# Product Change Notification

**Change Notification #:** 117435 - 00  
**Change Title:** Intel® ISDN Chipset for Terminals SB21150,  
PCN 117435-00, Transport Media,  
Carrier Tape & Cover Tape Change  
**Date of Publication:** February 24, 2020

New Carrier Tape Design Image (for reference only)\*:

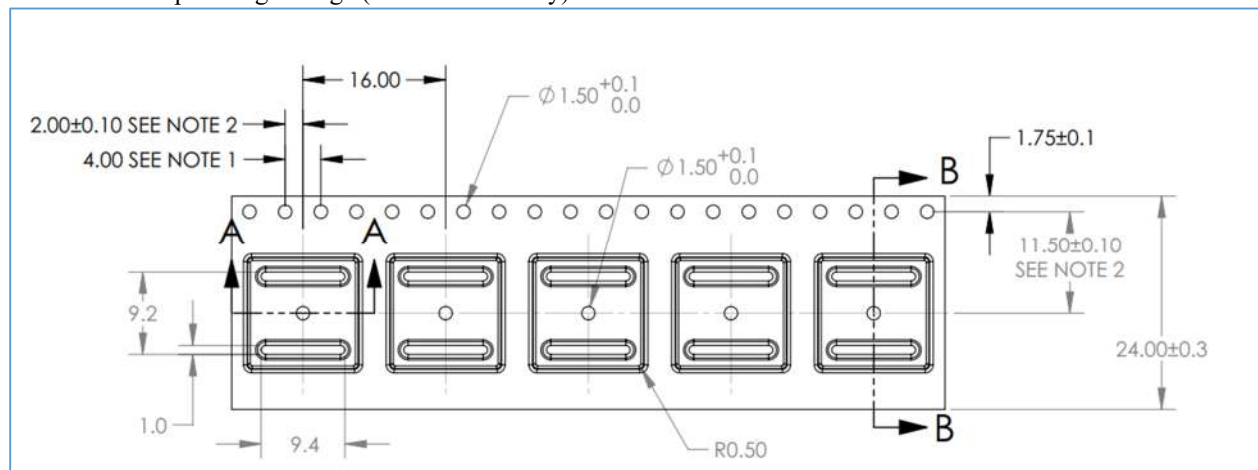
Due to end of life of tooling for the current carrier tape, Intel will replace and qualify a new carrier tape and new cover tape for the product listed in the Products Affected / Intel Ordering Codes table below.

Current Carrier Tape P/N: MA021563

Current Cover Tape P/N: 3M-26998

New Carrier Tape P/N: 500399869

New Cover Tape P/N: 500177726/500066311

There is no change which will have an impact on product performance, appearance, quality, reliability, interchange ability, functionality, or customer handling and manufacturability. However, there is a supplier change (due to EOL of tooling at current supplier), on both the carrier tape & cover tape resulting in a decrease total quantity per reel, evident at the customer site. The quantity per reel will decrease from 1900 to 1700.

**\*New Carrier Tape Design Drawing Notes:**

1. 10 SPROCKET HOLD PITCH CUMULATIVE TOLERANCE  $\pm 0.2$
2. POCKET POSITION RELATIVE TO SPROCKET HOLE MEASURED AS TRUE POSITION OF POCKET, NOT POCKET HOLE.
3. A<sub>o</sub> AND B<sub>o</sub> ARE CALCULATED ON A PLANE AT A DISTANCE "R" ABOVE THE BOTTOM OF THE POCKET.
